UNION CARBIDE CORPORATION  
MEDICAL PRODUCTS DIVISION  
P.O. BOX 324, TUXEDO, NEW YORK 10987  
TELEPHONE: 914-351-2131

Reference: Docket 50 - 54

## UNION CARBIDE NUCLEAR REACTOR

### Specification 3.5.1 c(1):

FIGURE 2

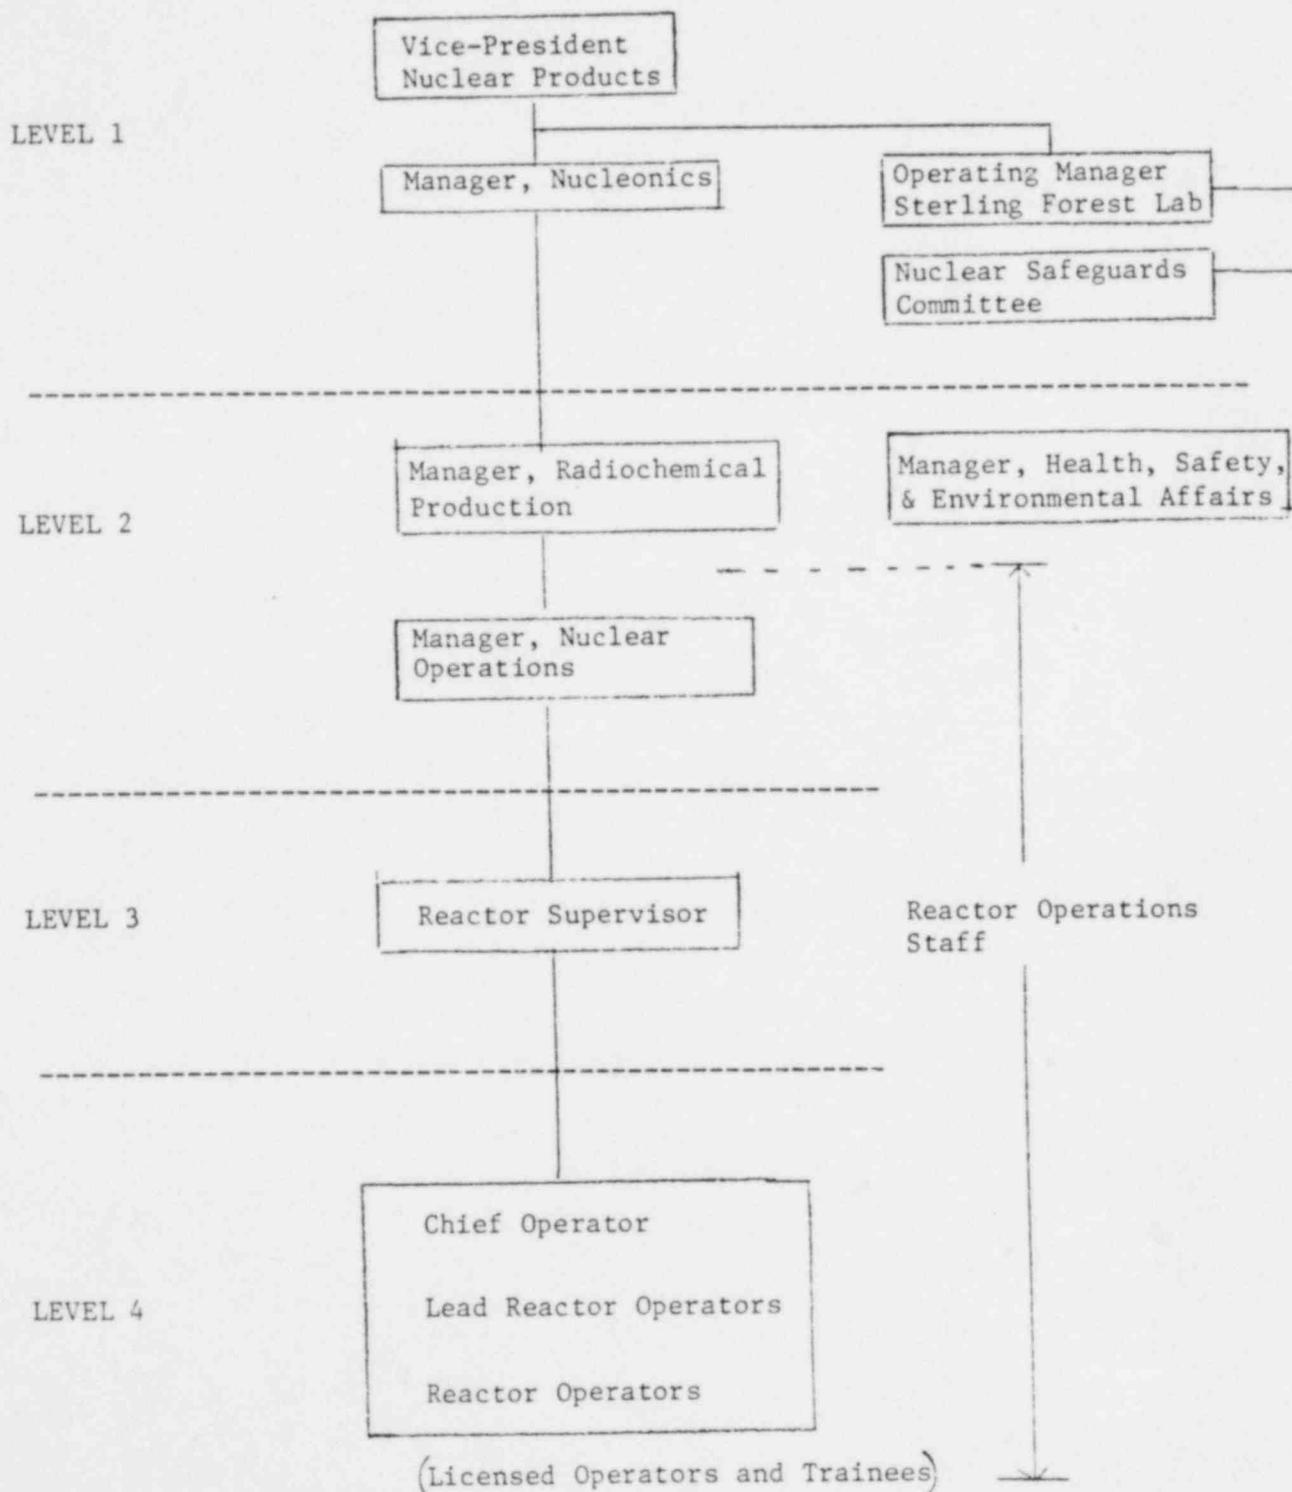
- (a) Specification 3.5.1 c(1): This refers to the potential reactivity of all experiments combined. Attached to this letter is our justification for retaining the present wording of our proposed specifications, including a copy of the related specifications from two other research reactors.
- (b) Organization Chart: A revised chart is attached that designates the levels and describes the current organization structure.
- (c) Specification 6.6.1: It was agreed that we would retain for two years those portions of pertinent recorder charts showing the course of unscheduled shutdowns. "Unplanned transients" have been included, at your request, by modifying the definition as follows:
